STATE OF VERMONT
PUBLIC UTILITY COMMISSION

Case No. 18-0974-TF

Tariff filing of Green Mountain Power Corporation requesting a 5.45% increase in its base rates effective with bills rendered January 1, 2019, to be fully offset by bill credits through September 30, 2019

PREFILED DIRECT TESTIMONY OF

The following graph is the 5-year history of expenditures for electric meters in 2018 dollars as provided in GMP's work paper for blankets on meters.

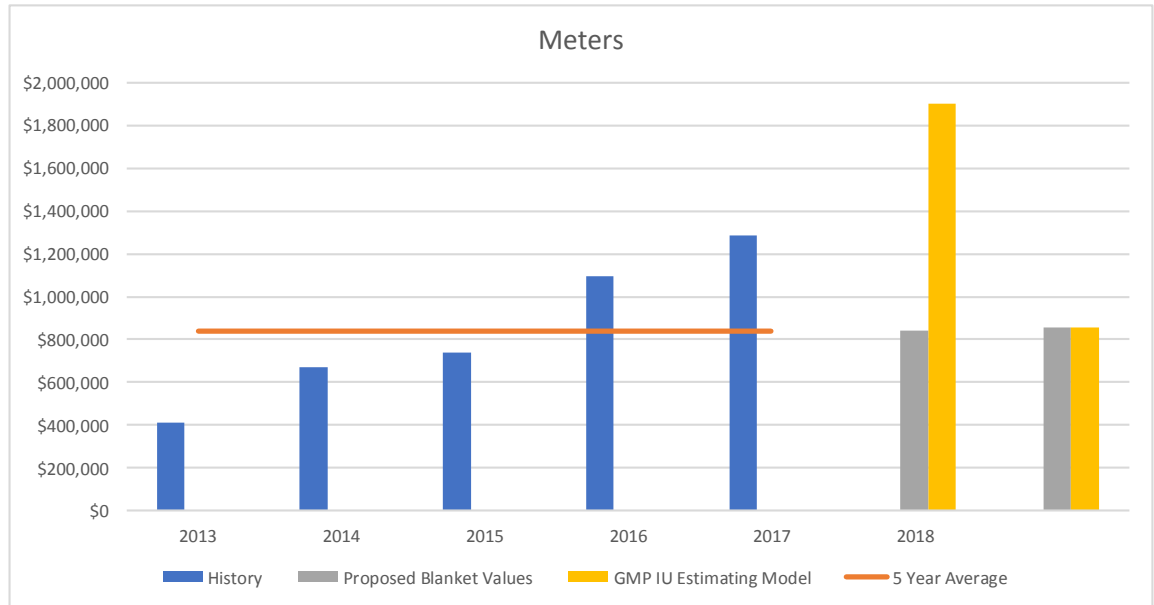
5
6 GMP used its UI Tool to estimate the 2018 expenditures for meters and concluded the
7 total cost would be \$1,901,149. This value is shown on the previous Graph and
8 reflects the continued uncontrolled increase in meter costs. Then in the following year
9 (2019) GMP's UI Tool estimate for meter costs is \$835,063 which is less than the
10 five-year average.

11
12 That is a change in predicted expenditures for meters of more than \$1.1 Million or
13 227%. How can a rate payer have any confidence in the validity of GMP's estimates
14 for a category of capital spending that should reflect no growth or changes because the
15 system is brand new and the addition of consumers is consistent from year to year?

16
17 I believe it would be appropriate for all meter costs as presented by GMP to be
18 disallowed from rate base. In addition, if GMP can clearly demonstrate the cost of
19 meters for new customers to be added in the rate effected period, then those meters
20 should be included. Reference my Exhibit PSD-KJM-9.

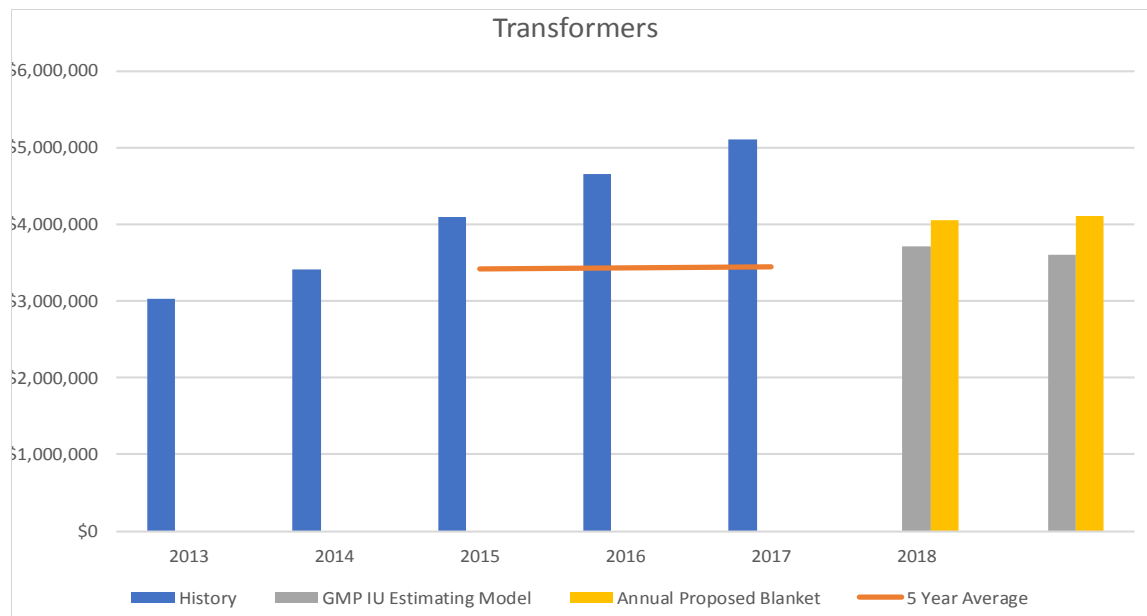
1 The future expenditures related to regulators and capacitors are not known and
2 measurable costs. These costs are for replacement of aged equipment and in some
3 cases to maintain adequate voltage on the system. The adequacy of voltage, or
4 specifically response to changes in voltage that require regulators or capacitors are due
5 to load increases on the distribution system. However, GMP load forecasts show a
6 decrease in energy sales, thus the need for additional regulators and capacitors is very
7 limited.

9 Since the costs for this blanket work order are not known and therefore cannot be
10 measured, I believe it would be appropriate to disallow the 2018 and 2019 work orders
11 related to regulators and capacitors with a total cost of \$1,696,412 from the rate base
12 for this case. Reference my Exhibit PSD-KJM-9.
